PARTS BULLETIN No. 4-15

04-03-15

Subject: NEW PART - HEAT EXCHANGER CORE WITH INTERNAL BYPASS
- HEAT EXCHANGER CORE UPGRADE KIT
- HEAT EXCHANGER ASSEMBLIES WITH INTERNAL BYPASS

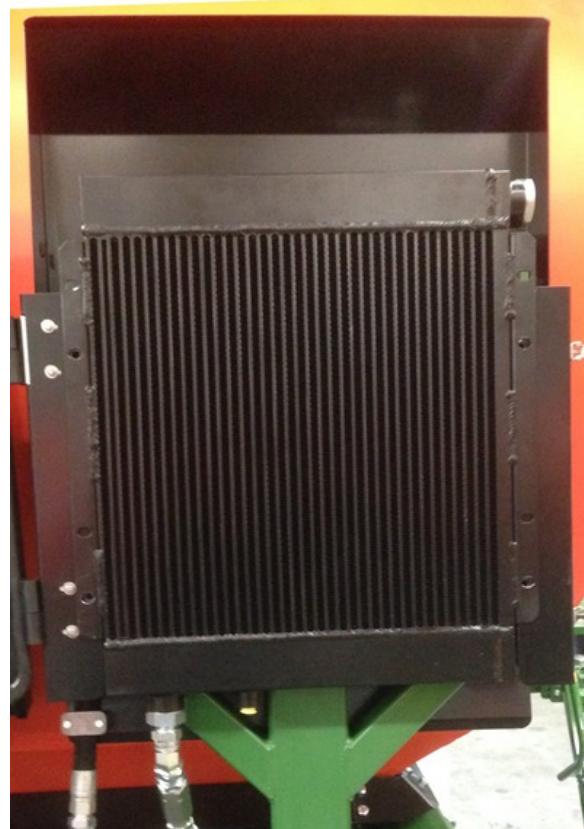
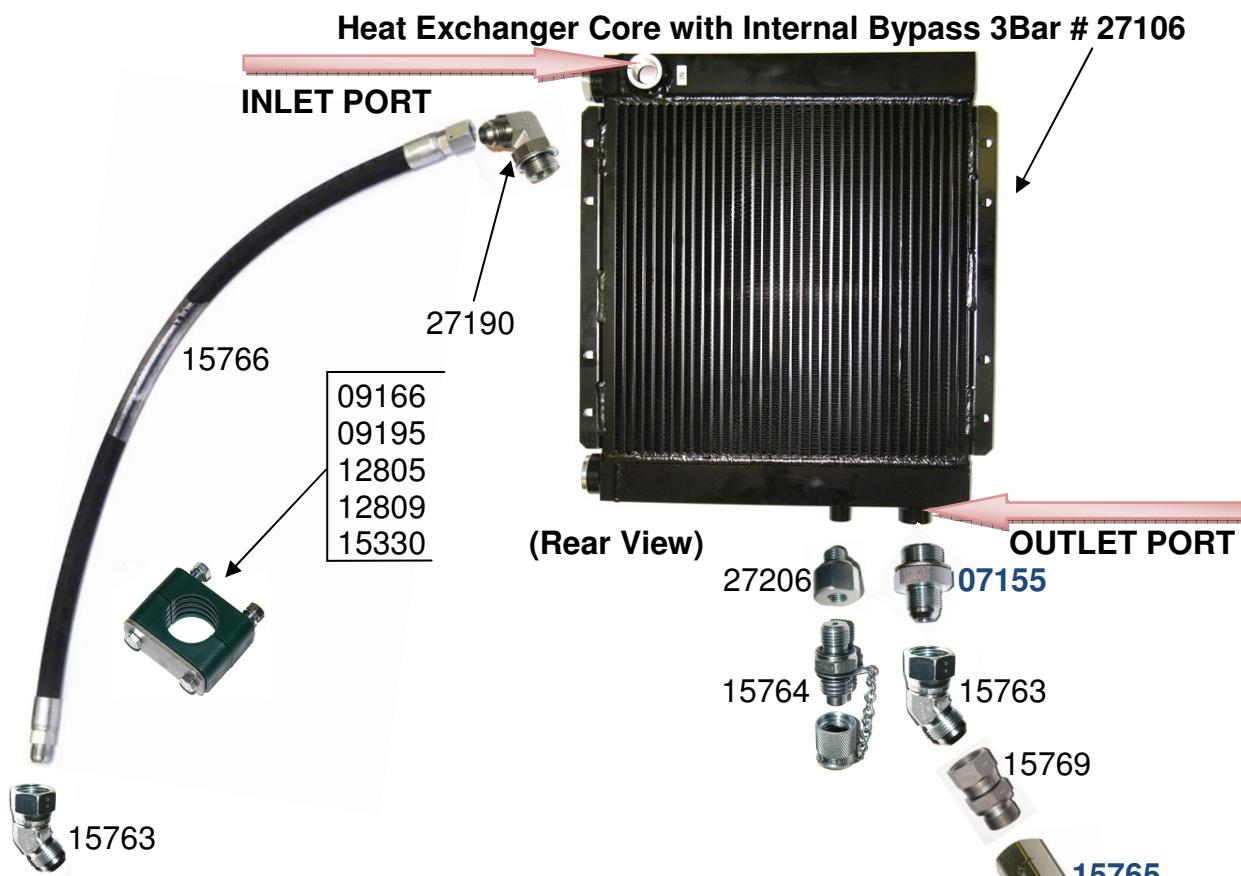
In late 2014 Ausplow made changes to Multistreams hydraulic heat exchanger core. The external fittings including 5 bar hydraulic check valve, elbow, and tee fittings are now incorporated inside the heat exchanger core.

This action has reduced the physical connections and therefore potential leaking points.

Old Style

New Style

The heat exchanger cowl, frame, and rear cover are compatible with the new style core element, but the core is **not** directly interchangeable without hydraulic hose upgrade kit Part Number 15768.

Once stock has been depleted of heat exchanger core P/N 07271 (old style),
customers will need to upgrade to the new style heat exchanger core with internal bypass, using upgrade kit P/N 15768 for replacement.
